**SNOWMOBILES**

No. **98-1**

Date: October 17, 1997

**SUBJECT: Fixed Half Splines**

VIEW FROM AIR SILENCER SIDE

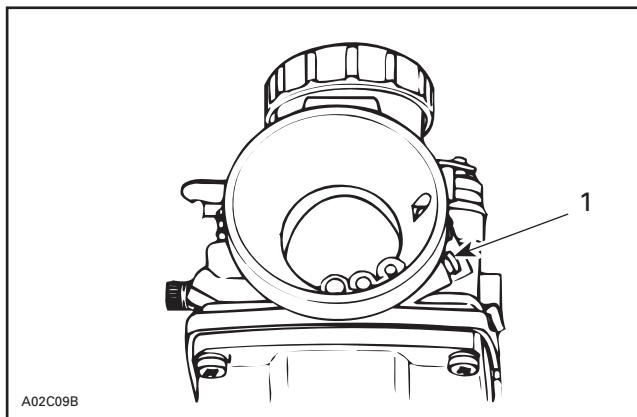
Adjust air screw to **1.5 turns** on both carburetors.

**CORRECT POSITION OF SUPPORT WHEEL**

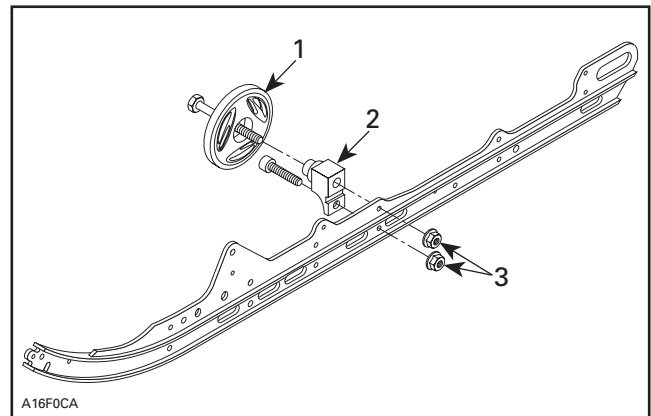
When suspension is compressed under normal riding conditions, the center support wheels may come in contact with upper track support wheels.

Remove center support wheels on both sides and reinstall in the next mounting hole to the rear on slide rails.

Remove support from rail and reinstall in the next hole to the rear on the rail.

1. Rivets

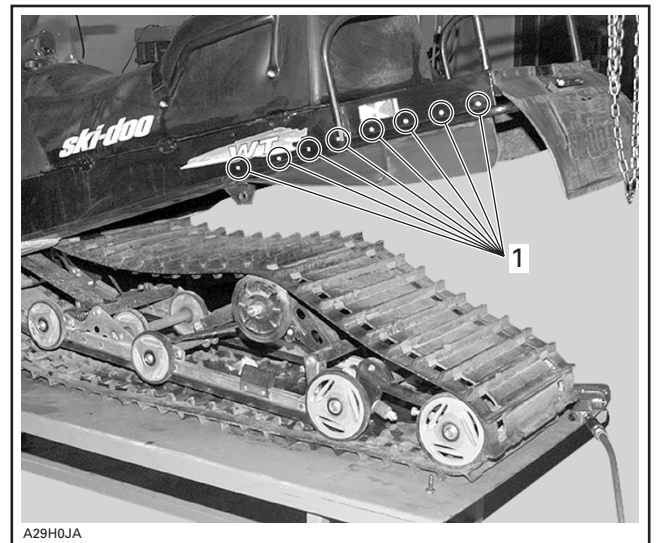
The end of the rivets retaining the side snow flaps are exceeding inside the tunnel and may come in contact with the side of the track.

Flatten out the exceeding portion of the rivets inside the tunnel.

ADJUST FLOAT HEIGHT TO NEW SPECS.

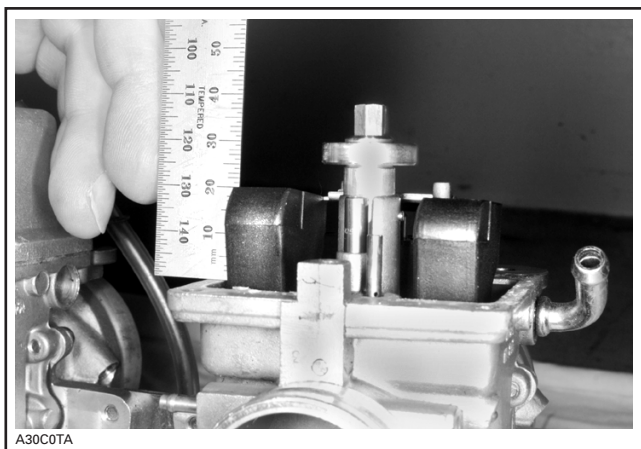
- a. With carburetor upside down on a level surface and a ruler in line with main jet hole, adjust float level at 21 mm (+0, -1) (0.827 in (+0, -0.039)). Refer to following photos.

**ELECTRIC FILTER HARNESS**

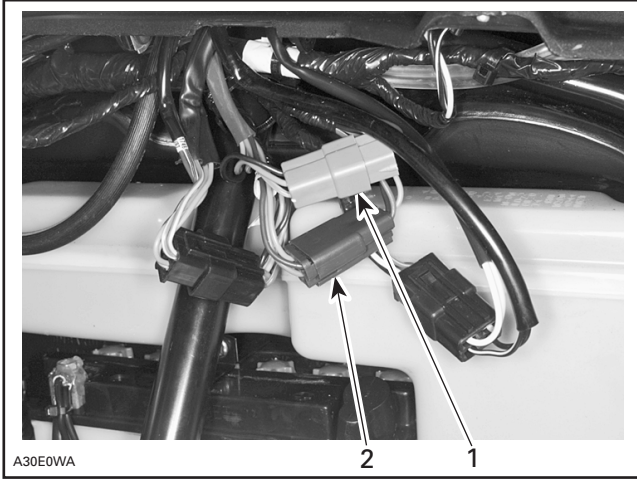
If owner complains about this situation, install an electric filter between housing connectors of main wiring harness.

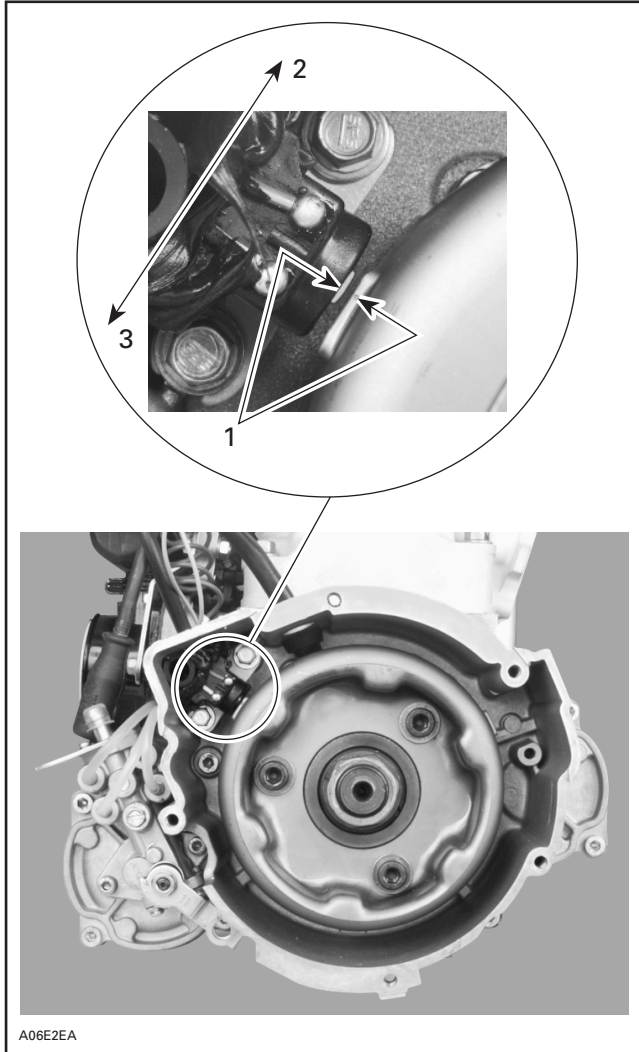
Set the piston at 1.65 mm (.065 in) before top dead center (BTDC).

Align the dot located on the side of the magneto flywheel protrusion with center of trigger coil core.
